**City of Phoenix**  
PLANNING AND DEVELOPMENT DEPARTMENT

**Staff Report Z-28-22-8**  
**July 11, 2022**

Single-family residential

Northwest corner of 23rd Avenue and  
Baseline Road

Conceptual Site Plan, Source: Paradigm Design

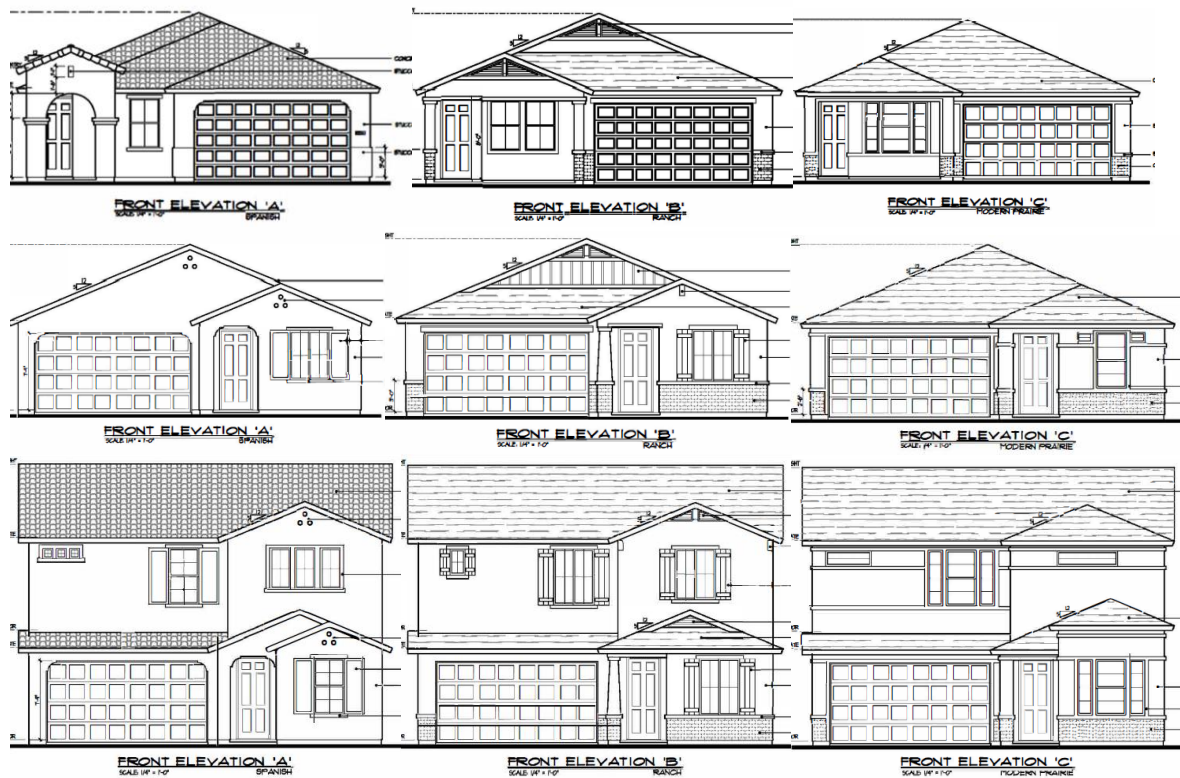
Conformance to the conceptual site plan provided by the applicant is not recommended by staff as this plan would require a technical appeal, via a separate process, to develop a new subdivision without connecting to the adjacent street stub on 23rd Drive. However, staff recommends Stipulation Nos. 1 and 2 to ensure the development does not exceed the number of lots depicted in the conceptual site plan and for a larger percentage (10 percent) of open space to be provided on the site than required by the Zoning Ordinance. Stipulation Nos. 3 through 5 as recommended by staff, address landscaping enhancements along perimeter landscape setbacks to help maintain the character of the neighborhood and provide a transition in concert with the goals of the Rio Montaña Area Plan.

1. The development shall not exceed a maximum of 55 lots.
2. A minimum of 10% of the gross site area, exclusive of required landscape setbacks, shall be provided as open space, as approved by the Planning and Development Department.

20. The developer shall connect to 23rd Drive, or dedicate a 50-foot radius cul-de-sac and construct a 45-foot turning radius on site at the termination of 23rd Drive, as modified and approved by the Planning and Development Department.

Conceptual Front Building Elevations,  
Source: The Haley Group

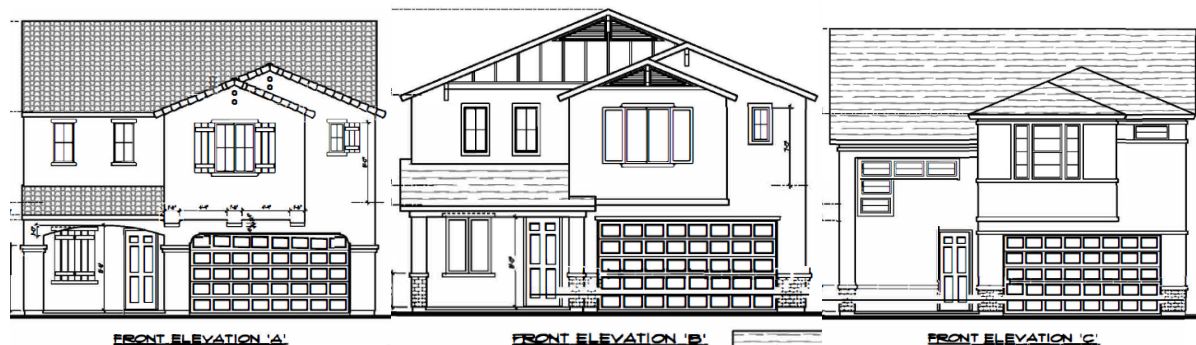
Staff does not recommend conformance to these building elevations as the Rio Montaña Area Plan mentions porches as an architectural design element to include for single family residential developments.

Due to the proposed lot widths, all lots will be subject to the Single-Family Design Review standards outlined in Section 507 Tab.A.II. of the Zoning Ordinance. However, Stipulation No. 7 requires that a minimum of 75 percent of the front building elevations for each floor plan shall provide a minimum 60 square-foot covered front porch at a depth of at least six feet. This design feature will reinforce community orientation, consistent with the Rio Montaña Area Plan.

7. A minimum of 75 percent of the standard building elevations provided shall include a covered front porch in the front yard with a minimum of 60 square feet in area and a minimum depth of 6 feet. No porch shall terminate within the plane of a door or window, as approved by the Planning and Development Department.

Conceptual Site Plan with Planning and Development Department annotations,  
Source: Paradigm Design

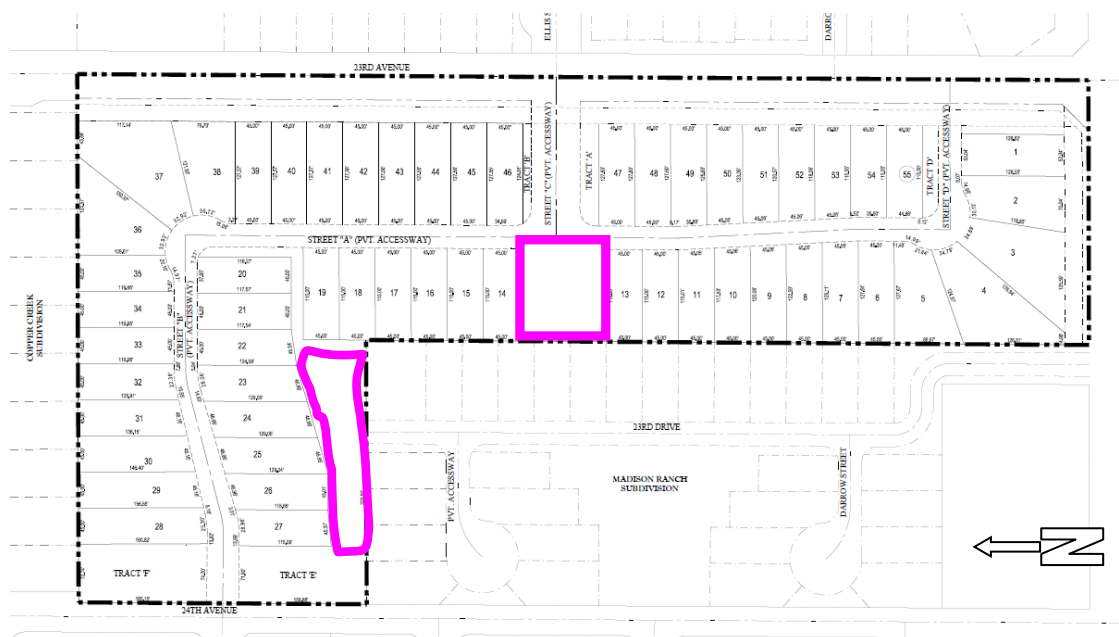
7. Fencing and wall enhancements are addressed in Stipulation No. 9 and include partial view fencing consisting of a minimum three-foot view fence and a maximum three-foot solid wall adjacent to the primary centralized open space area. These elements will increase visibility within this area and promote an open feel.

Perimeter wall enhancements along adjacent public streets are also addressed in Stipulation No. 8 and will help to improve the streetscape by providing visual interest via wall-offsets and material and textural differences.

The development proposes vehicular and pedestrian access to the community along 23rd Avenue and 24th Avenue. Staff recommends Stipulation Nos. 9 and 10 to ensure that entryways along 23rd Avenue and 24th Avenue incorporate decorative material and a variety of plant materials on both sides of the entryway for visual interest.

8. The conceptual site plan also depicts various open space areas distributed throughout the development for future residents to enjoy. Staff recommends Stipulation Nos. 11 and 12 to require several amenities distributed throughout the development including:

8. Fences and walls shall be in general conformance with the wall plan and wall details (wall elevations) date stamped April 1, 2022, as modified by the following stipulations, and approved by the Planning and Development Department:

- a. Partial view fencing, which may include solid columns up to 24 inches in width, shall be utilized where walls are proposed around open space areas, the partial view fencing shall be a maximum 3-foot solid wall and 3-foot view fencing.

- b. Perimeter walls bounding the rear or side yard property lines of residential lots along 23rd Avenue, 24th Avenue, and Baseline Road shall include minimum three-foot offsets, and material and textural differences, such as stucco, and/or split face or slump block or a decorative element, such as tile or stamped designs, as approved by the Planning and Development Department.

9. Project entry/exit drives along 23rd and 24th Avenues shall incorporate decorative pavers, stamped or colored concrete, or similar alternative material, as approved by the Planning and Development Department.

10. Project entry/exit drives along 23rd and 24th Avenues shall incorporate enhanced landscaping on both sides planted with a variety of at least three plant materials, as approved by the Planning and Development Department. Each landscaped area shall be a minimum of 250-square feet.

11. A tot lot with shade equipment shall be provided in the central/primary open space amenity area, as approved by the Planning and Development Department.
